**Re: Hydro One Networks Inc. 2020 Transmission Rate Application
EB-2019-0082**

Hydro One Networks Inc.
2020-2022 Transmission Rate Application

Power Workers' Union Interrogatories

Figure 1 - Number of Assets beyond ESL per Year Summary

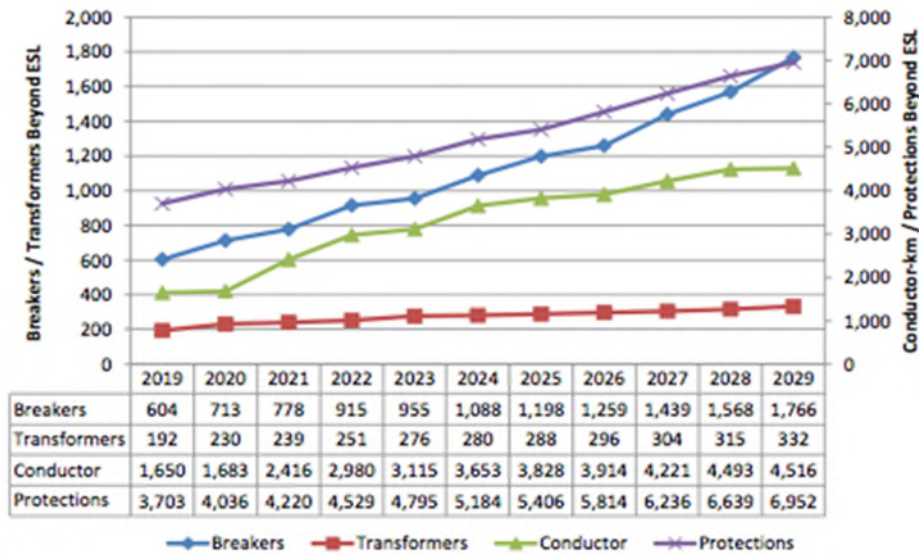
- a) The PWU’s understanding is that the deferral of capital investments would typically create pressure on OM&A costs. Please explain how HO’s proactive and strategically paced investments can prevent pressure on both OM&A and capital costs at the same time.
- b) Please reproduce the table in Figure 1 (for the 2019-2024 period) indicating the percentage or share that the ESL numbers represent.

Table 4

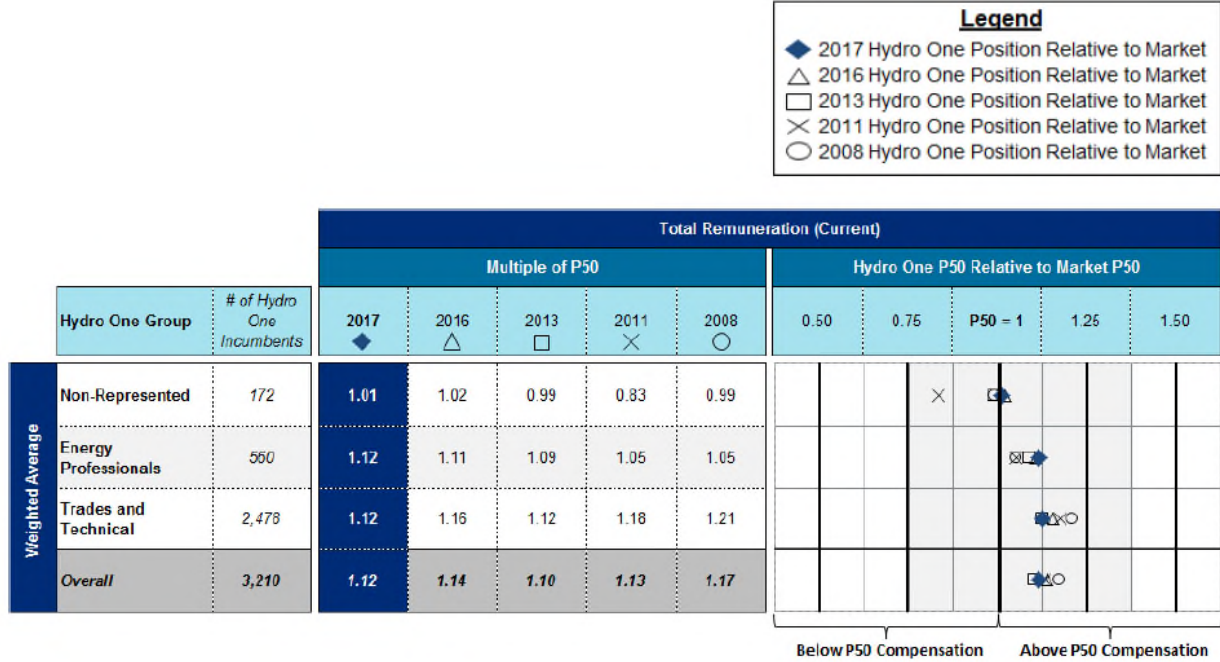
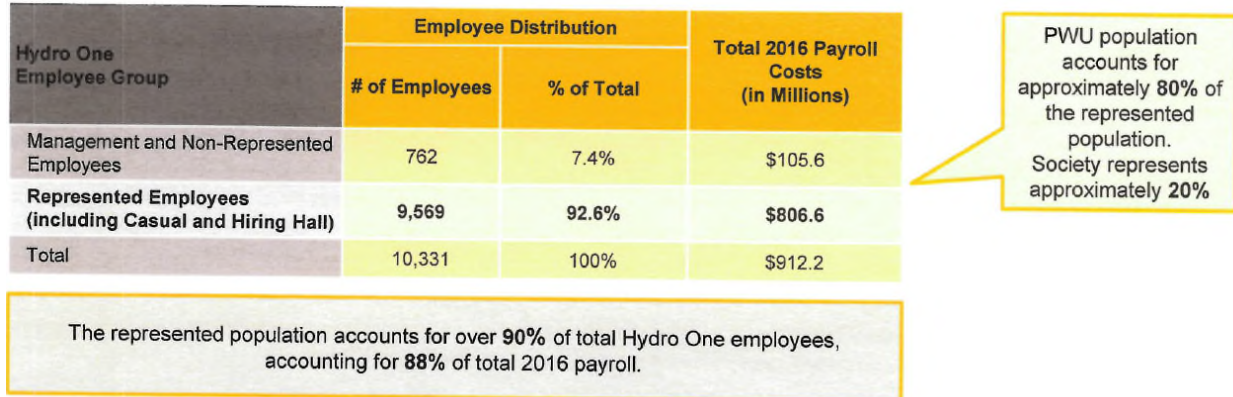
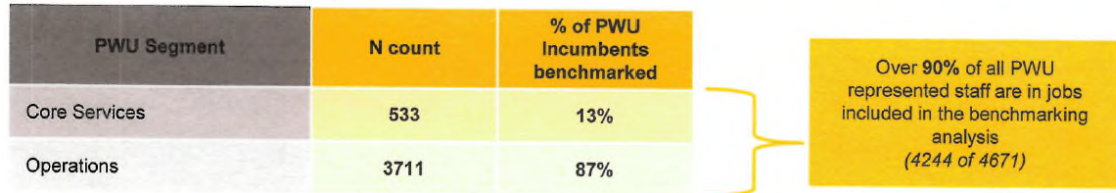
- a) Why is Mercer only able to benchmark 2,478 PWU incumbents and Willis Towers Watson is able to benchmark 4,244 PWU incumbents?
- b) Which positions was Willis Towers Watson able to benchmark that Mercer was not?
- c) Is it Hydro One's opinion that Willis Towers Watson's study is more reflective of Hydro One's relative compensation because it encompasses a much greater share of its employees? Please explain.

Figure 10 – Number of Assets Beyond End of Service Life Per Year Summary

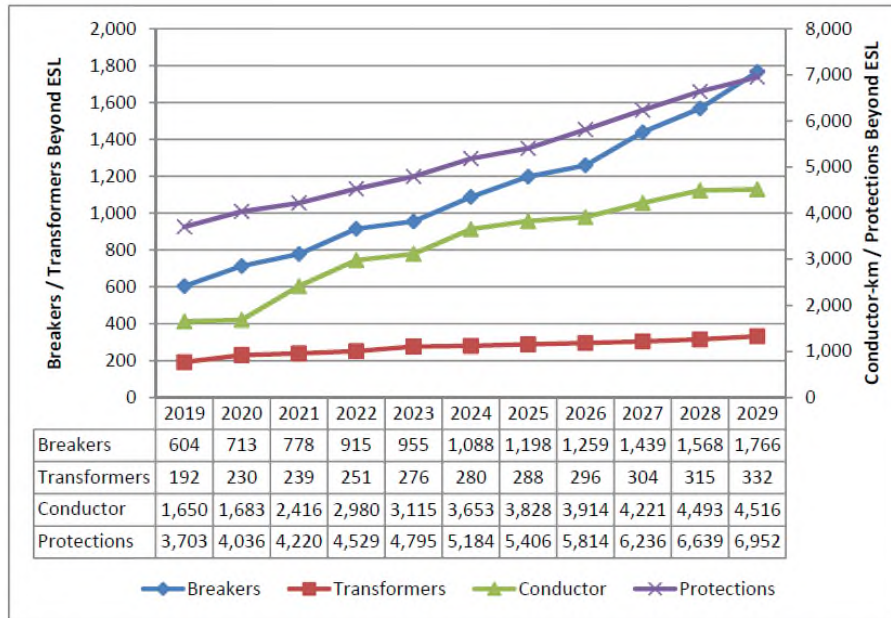
- a) What is the demographic profile at the end of the rate period assuming the plan is completed?

Figure 3-2 shows the number of transformers by vintage.

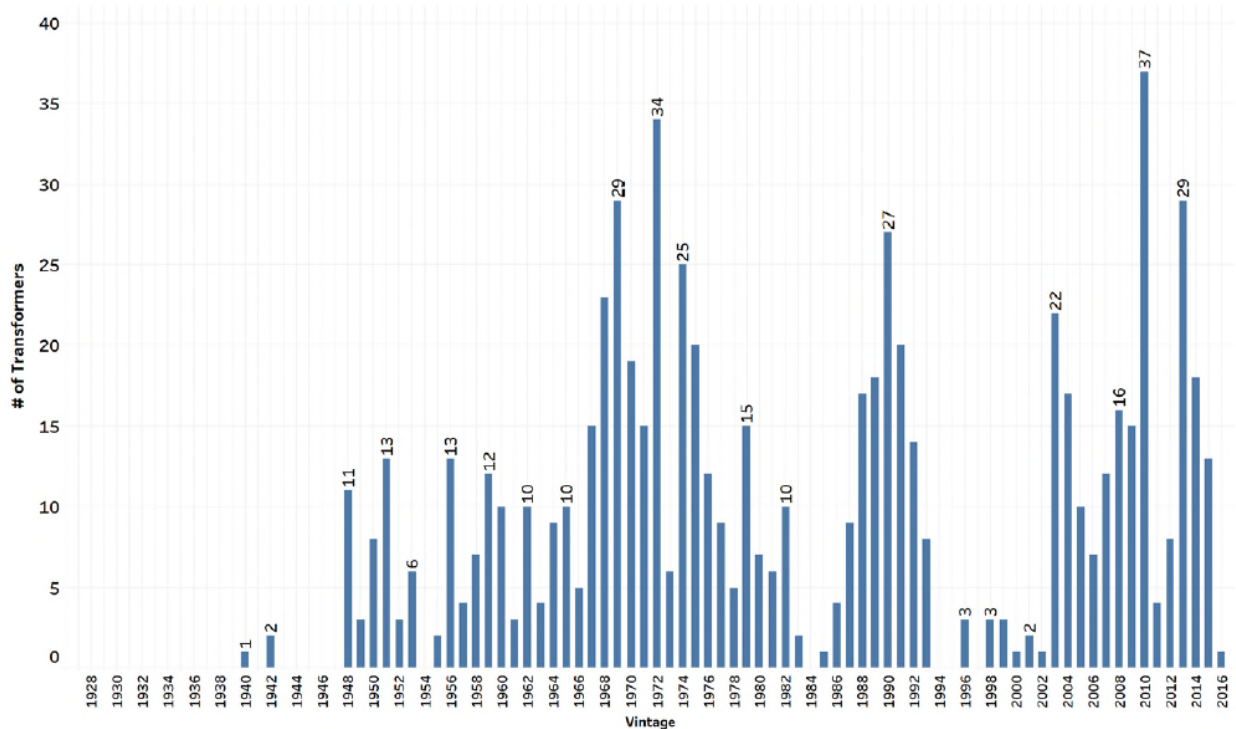
a) What will this chart look like at the end of the test period?

Figure 4-6 shows long-term and short-term risk for Hydro One’s 230 kV units using the five-category ranking.

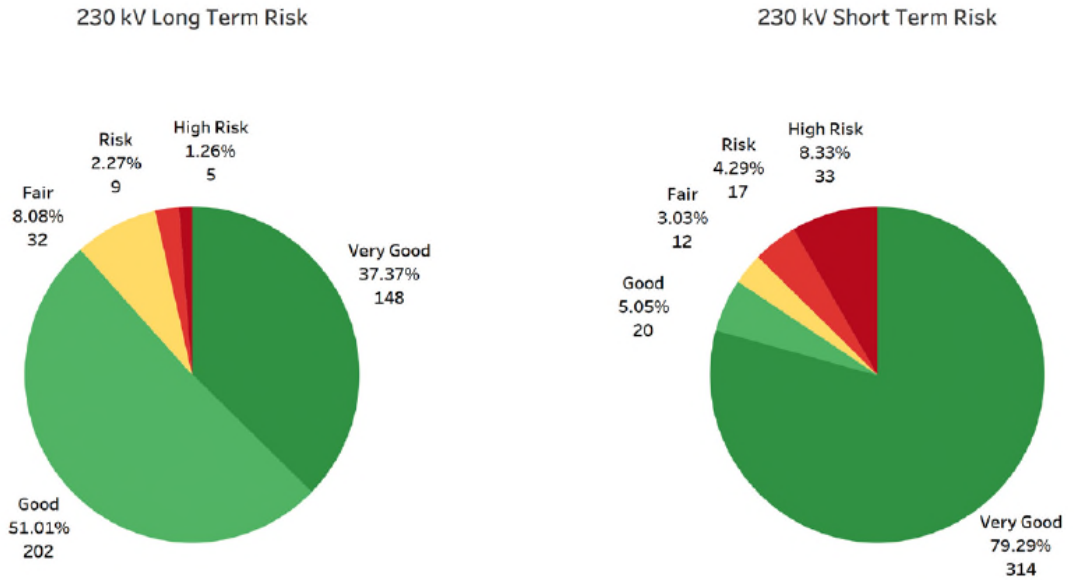
- a) What does “short term” and “long term” mean in this context?
- b) Please define “high-risk”. Is it a measure of the probability of failure? If so, what is the threshold?
